### CHANGE ORDER

PROJECT:  
Bellaire Blvd. from FM 1464 to San Pablo Drive  
Paving and Drainage Improvements.

CHANGE ORDER NUMBER ..... 03  
DATE ..... 2/9/2018

The contract is changed as follows:  
Add Block Sodding for Erosion Control; Paving, Interceptor Structure, & Drainage Piping for Maintenance Access at the San Pablo Bridge; Delete Bid Item Quantities Not Necessary to Complete the Work; and Add 14 Calendar Days to the Project Duration due to Severe Weather Events and to Complete the Maintenance Access.

**Date:** February 12, 2018  
**To:** Robert Baker  
**From:** Michael Boenig, Project Manager Allgood Construction Co., Inc.  
**Subject:** Requested pricing for a slope intercept on the south side of the San Pablo Bridge.

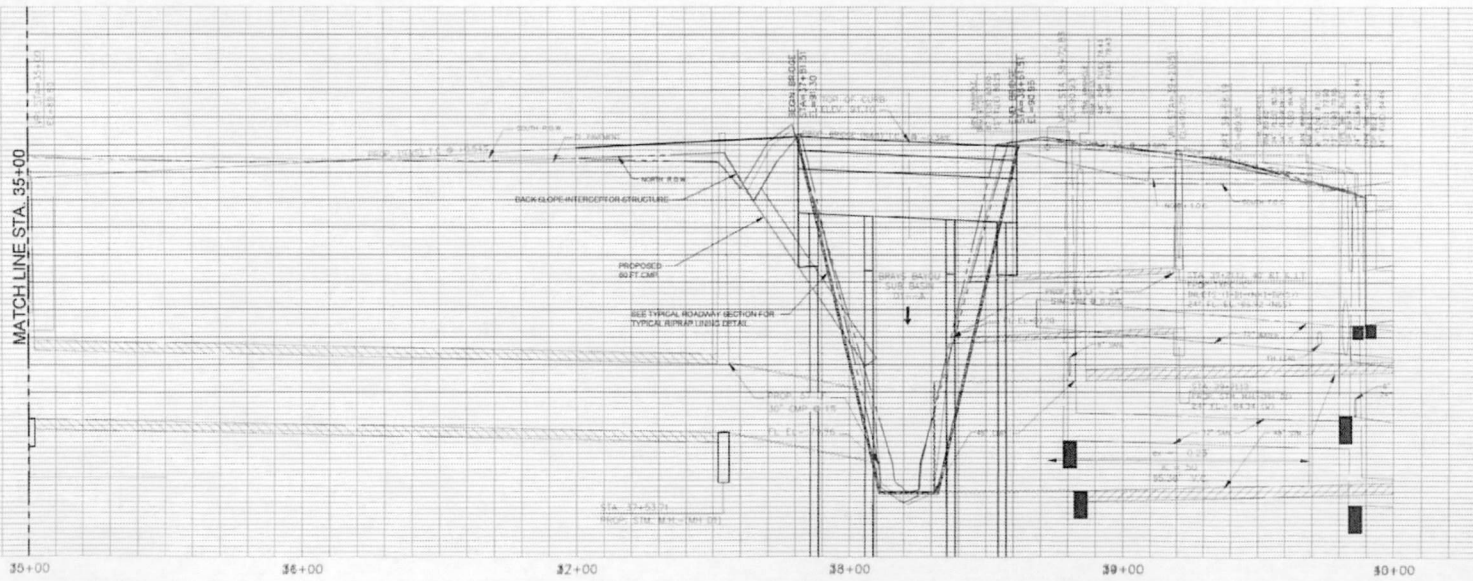
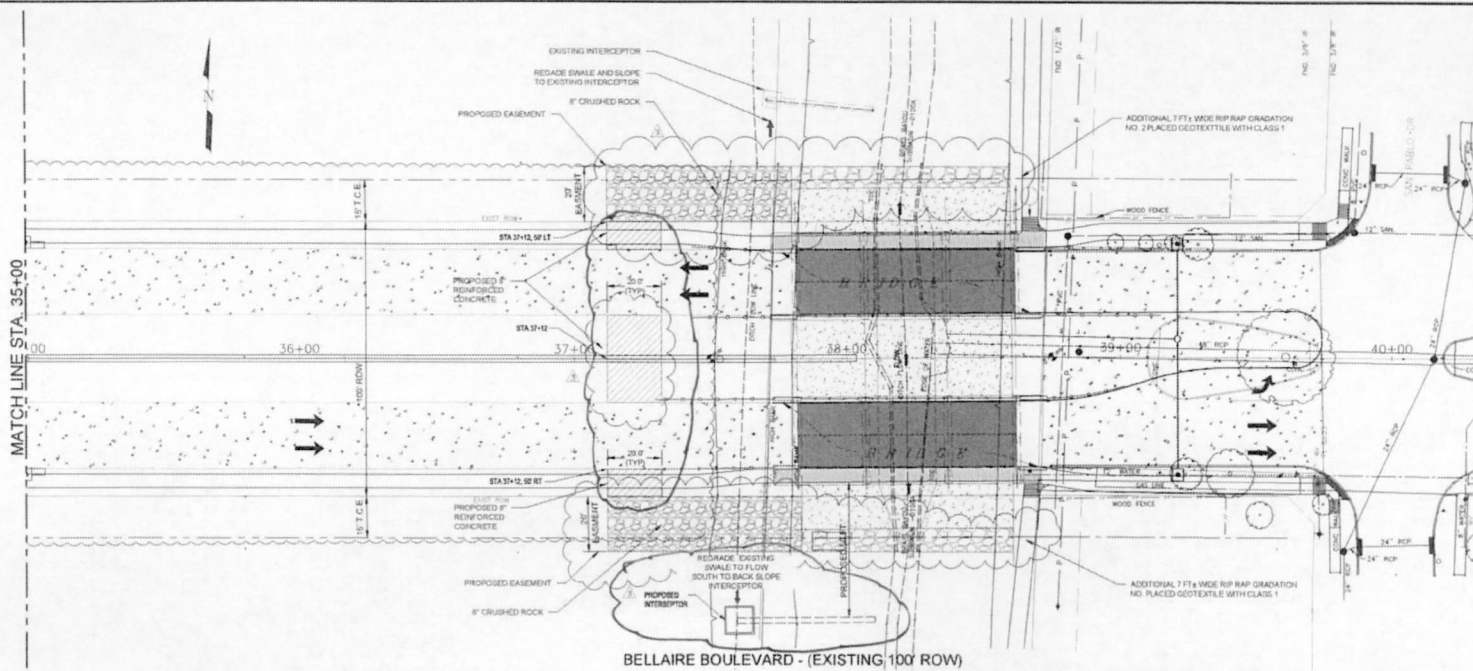
The purpose of this document is to confirm the price requested for the new item of a slope intercept for a 30" CMP at appx. STA 37+75 RT 75.00. Per plans provided on 2/7/2018.

- Qty 1- Slope intercept for 30" CMP – Price \$2,500.00 EA

**BELLAIRE BLVD  
PLAN AND PROFILE  
STA 35+00 TO STA 40+00**

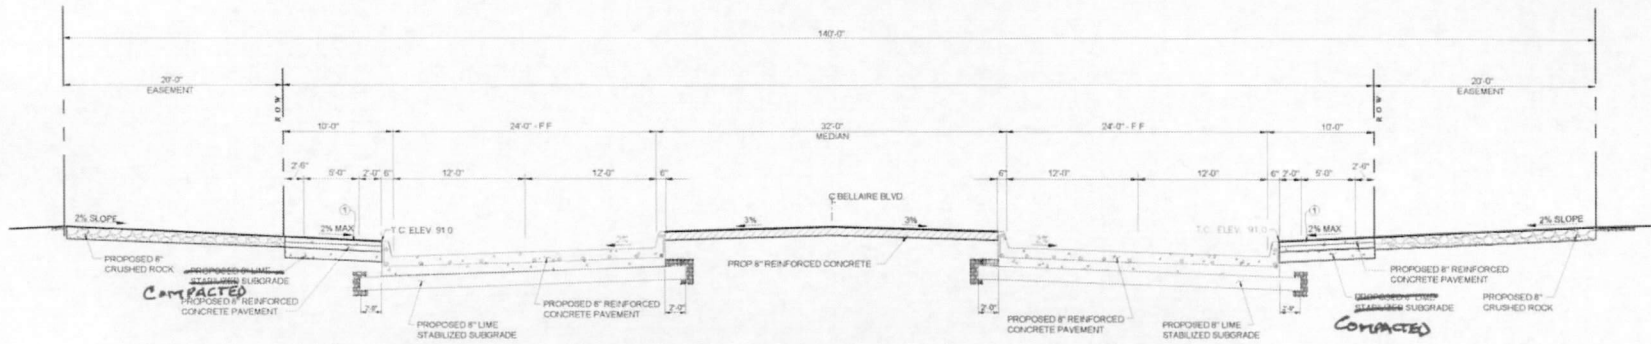
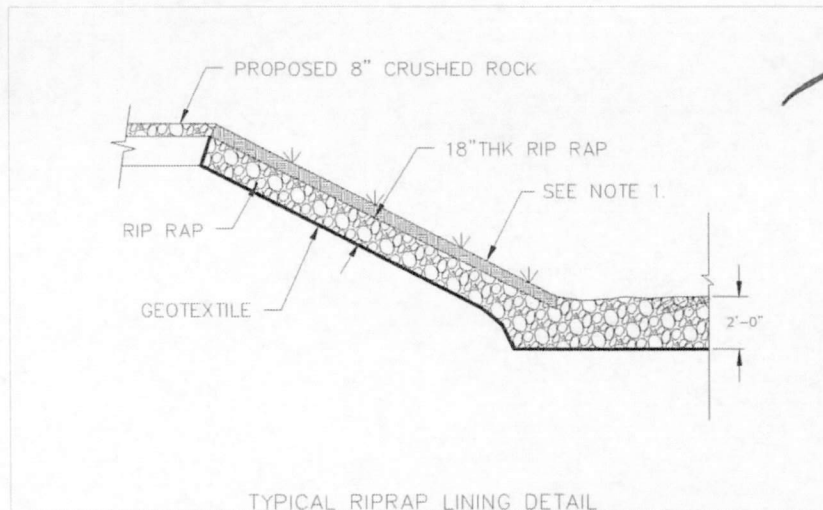
- NOTES:**
- (1) SAWCUT, REMOVE AND DISPOSE OF EXISTING PAVEMENT TO EXISTING CONCRETE PAVEMENT WITH PROPOSED PAVEMENT HEADER
  - (2) REMOVE AND DISPOSE OF EXISTING CONCRETE PAVING AT FILL DEPTH
